# Access Compliance Report

## Public Rights-of-Way

### (Curb Ramps)

Intersection ID: 44540	Main Street: NEAL_RD	Cross Street: UNIVERSITY_CITY_BV	Location: E
ADA ID: C84E709C3403	Ramp Type: Perp	Initial Pass/Fail: Fail	Overall Compliance: No
		Severity Score: 8.75	
Codes/Mitigation Info/Possible Solution		Field Measurements/Component Compliance

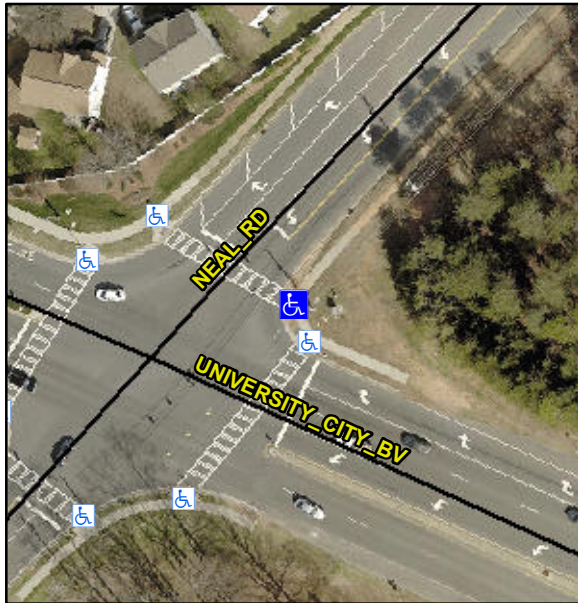
**Not Found, R304.5.1**

Compliance	Description	Data	Compliance	Description	Data
N/A	Ramp Length (in)	46.0	Yes	Ramp Slope (%)	8.0
No	Ramp Width (in)	47.0	Yes	Ramp XSlope (%)	0.9
N/A	Flare Type LT	N/A	N/A	Flare Type RT	N/A
N/A	Flare Slope LT (%)	N/A	N/A	Flare Slope RT (%)	N/A
N/A	Flare Traversable LT?	N/A	N/A	Flare Traversable RT?	N/A
N/A	Landing Length (in)	N/A	N/A	DWS Provided?	N/A
N/A	Landing Width (in)	N/A	N/A	DWS Contrast?	N/A
N/A	Landing Slope (%)	N/A	N/A	DWS Length (in)	N/A
N/A	Landing X Slope (%)	N/A	N/A	DWS Full Width?	N/A
N/A	Landing Curb? (Y/N)	N/A	N/A	DWS Offset (in)	N/A
N/A	Shared Landing?	N/A			
N/A	Gutter Ponding?	N/A	N/A	Gutter Slope (%)	N/A
N/A	Gutter Lip Ht (in)	N/A	N/A	Gutter X Slope (%)	N/A
N/A	Painted X Walk1?	Yes	N/A	Painted X Walk2?	N/A
	X Walk 1 Direction	To NW		X Walk 2 Direction	N/A
N/A	X Walk 1 Width (in)	105.0	N/A	X Walk 2 Width (in)	N/A
	X Walk 1 Slope (%)	1.8		X Walk 2 Slope (%)	N/A
	X Walk 1 X Slope (%)	1.6		X Walk 2 X Slope (%)	N/A

**Remove & Replace Entire Ramp.**
